Staff Report

To: Salt Lake City Historic Landmark Commission
From: Kelsey Lindquist, Senior Planner, (801) 535-7930
Date: August 27, 2020
Re: PLNHLC2020-00016

Minor Alteration

PROPERTY ADDRESS: 88 North R Street
PARCEL ID: 09-32-480-001-0000
MASTER PLAN: Avenues Master Plan, 1987
ZONING DISTRICT: SR-1A (Special Development Pattern Residential District)

Archived Photo of 88 R

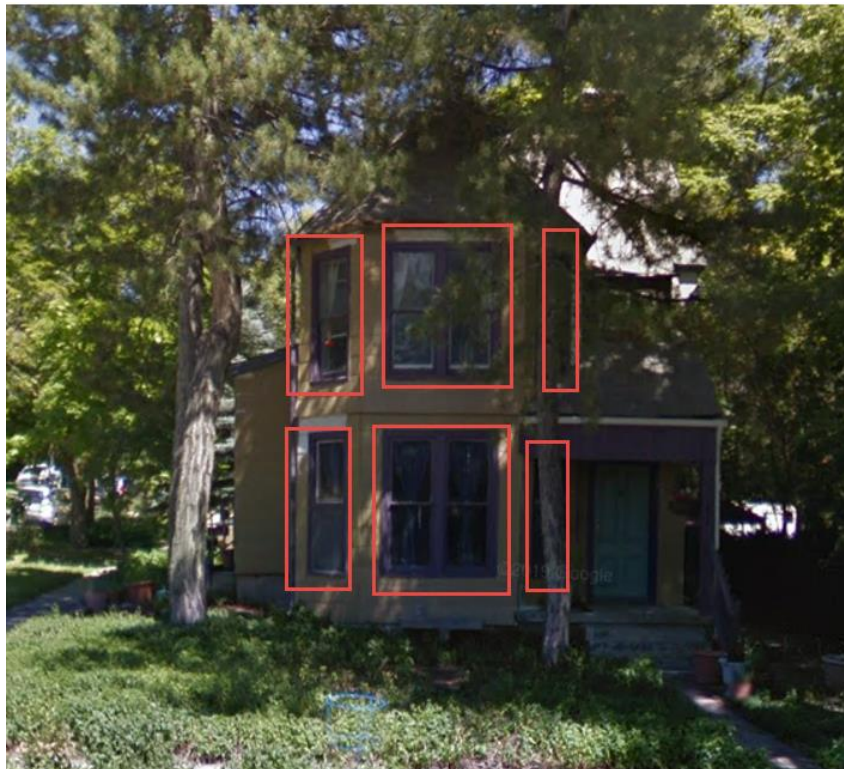
The modification to the windows that placed this property under enforcement, include the replacement of eight original windows on the primary elevation located in the two-story segmental bay. The replaced windows were wood and double-hung in style. The property owner removed these windows and installed vinyl picture windows on the front portion of the bay and single-hung windows on the first and second story sides of the bay.

In the case of original windows that are beyond repair, compatible and appropriate replacements are required. In the case of the subject property, the applicant replaced original double-hung windows with fixed picture windows on the front elevation. The side windows were replaced with single-hung vinyl windows. Additionally, the reveal of the original windows was lost with the removal and replacement. The vinyl windows were installed to be flush with the wall plane of the structure. The window trim has remained.

If denied, the recently installed windows would need to be replaced with windows in the appropriate style and material.

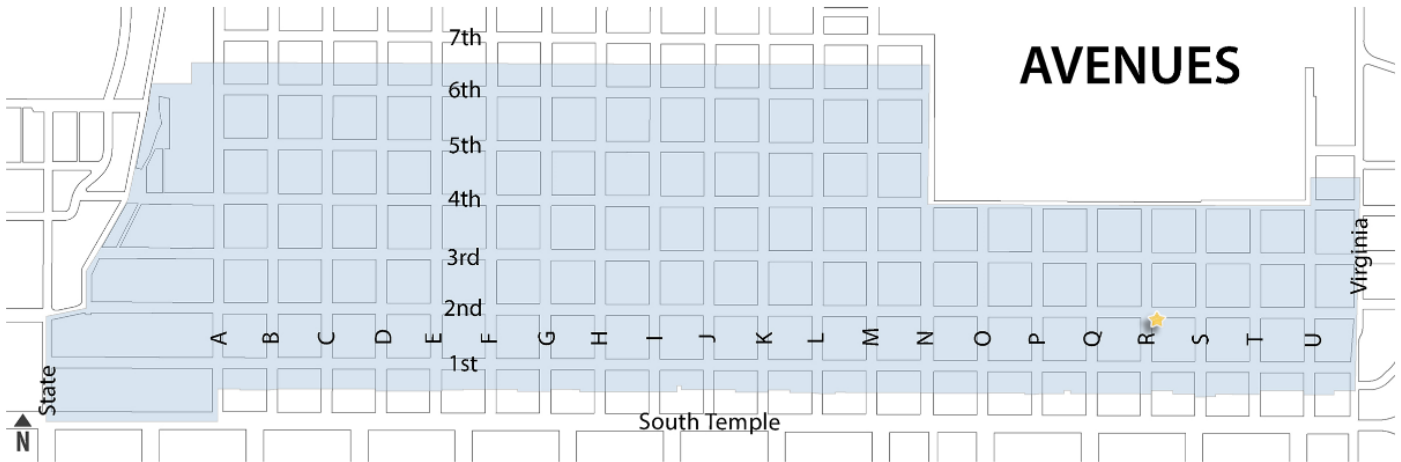
The subject windows were character defining features of the subject property. If a window is not a character defining feature, or readily visible from the public way, staff may administratively approve a request for repair or replacement. However, based on information contained within this report, the request to completely remove and replace a character defining feature is not in keeping with applicable standards.

Staff advised the applicant that approval of the certificate of appropriateness of the replaced windows is unlikely, due to the conflict with the adopted standards.

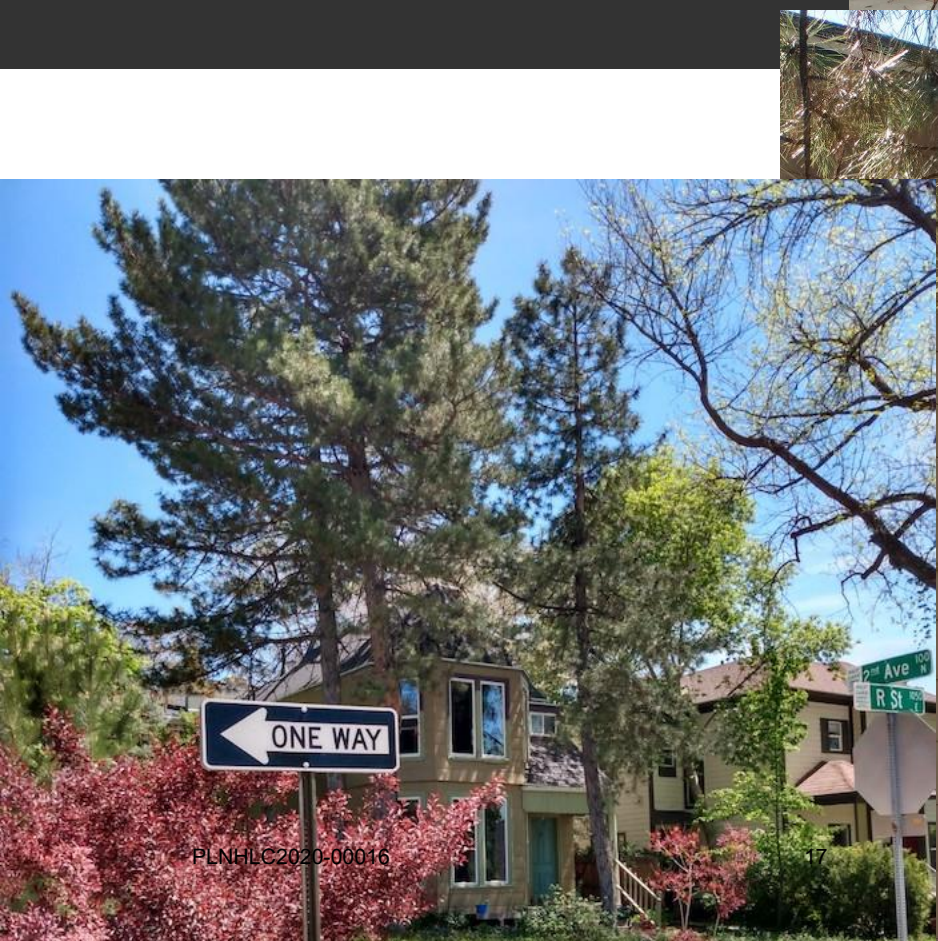
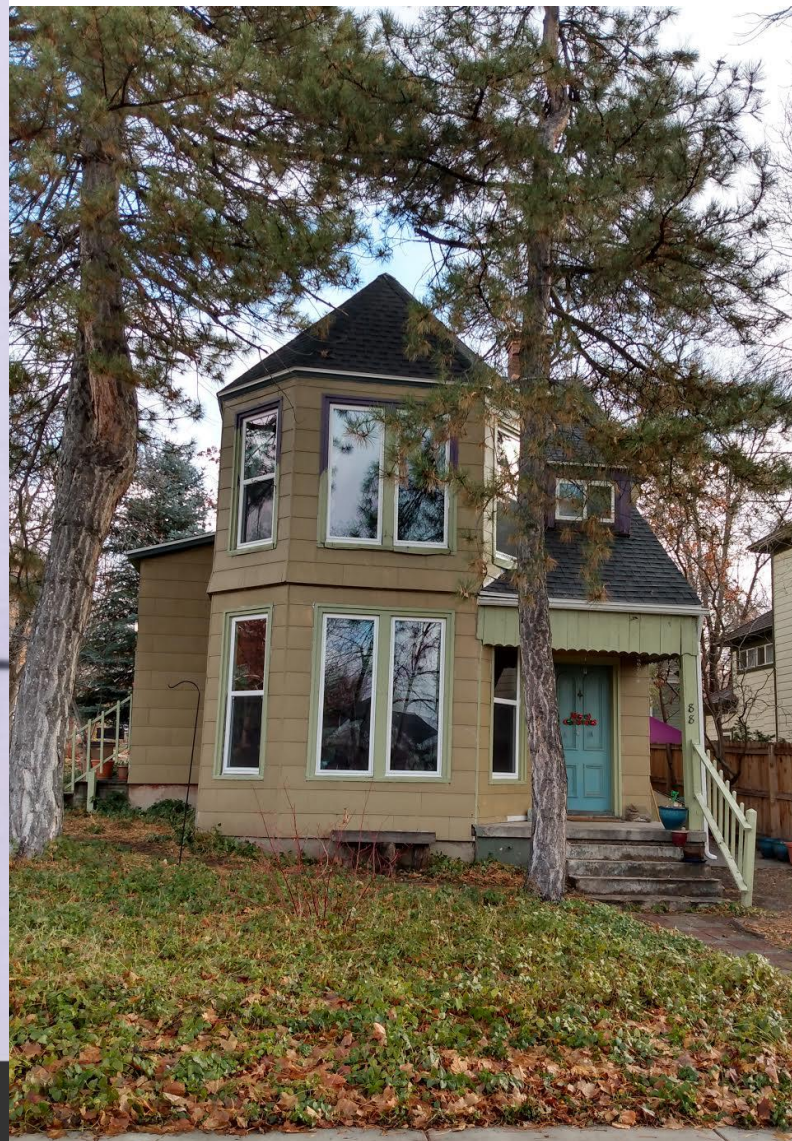
The only new feature that might be qualified as “affecting ... defining [historical] characteristics” of 88 R appears in the choice to have a single pane feature in the two center windows of the bay. This option was put actually forward by Advanced Windows Products at the time of the estimate (see photo. Page C).

Use of single pane thermal windows here does change the external appearance slightly. This could be remedied by careful installation on the exterior side of each permanent horizontally dividing cross-members. This would restore the original profile, while retaining the environmental benefit of thermal insulation for the house.
